GLENORCHY CITY COUNCIL
ATTACHMENTS
TUESDAY, 15 MARCH 2016

9. Intercity Cycleway Proposed Chicane Gate Changes at Road Intersections	
1: Standard Drawings D687E - Intercity Cycleway Standard Arrangement Detail at Road Crossings	3
2: MAV Targeted Risk Assessment Report	4
3: Midson Traffic Risk Assessment Report	39
4: Austroads Guide to Road Design Part 6A - Terminal Treatments	66

Targeted Risk Appraisal DRAFT Report Glenorchy to Hobart Cycleway

Council:	Glenorchy City Council
Location:	Glenorchy to Hobart Cycleway
Date of visit:	September 1 st , 2014
Date of Report:	November 1 st , 2014
Report by:	Daniel Brooks, Senior Risk Consultant Liability Mutual Insurance Risk Management

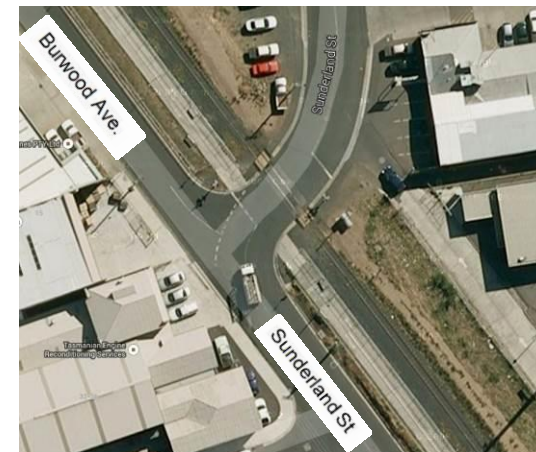
Comment: Third road crossing (travelling South to North) under the management of Glenorchy City Council (Sunderland Street), with the bottom image showing the intersection of Sunderland St and Burwood Avenue from the crossing point.

It is noted that warning signage is provided for road users approaching from all three directions.

This crossing is somewhat unique with the way Sunderland St. bends just prior to the crossing point, as well as the way that vehicles may also be turning in from Burwood Avenue (see google image below). This may make it difficult and/or confusing for pathway users to ensure the road is clear in all three directions.

Recommendation: Council's proposal is recommended to be implemented for all such road crossings, as this will provide better warning for cyclists of the impending road crossing, decrease the likelihood of collisions between users travelling in opposite directions, and in some cases (where the chicane gates are located closer to the road) allow riders to get clear of the road quicker.
